Madison Parks Division

NOTICE OF ADDENDUM ADDENDUM 1

CONTRACT NO.8062

Re: Geotechnical Exploration Report - REVISED
Proposed Bridge Replacements
Vilas Park Island
Madison, Wisconsin

SHEET
15

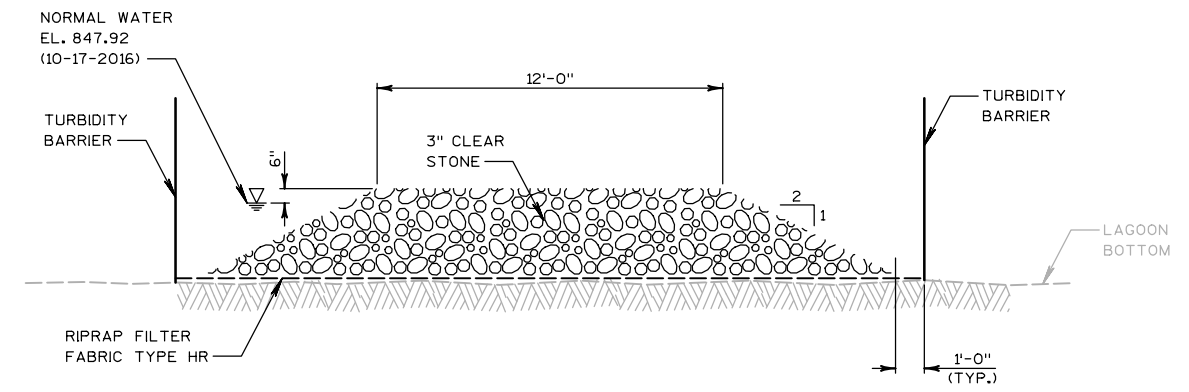
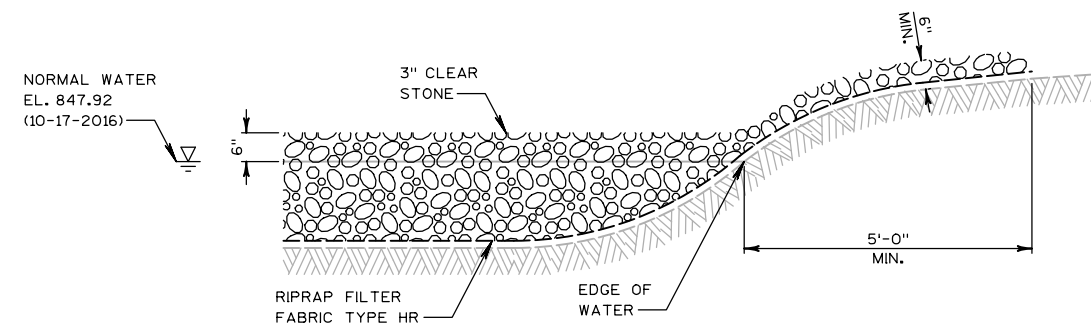
6. All Sheets.
Replace: At all locations on the drawings where the word 'helical' appears, replace it with 'deep foundation'.
7. Sheet 15.
Omit: full sheet.
Add: Sheet 15, revision dated 11-27-17. Per attached.
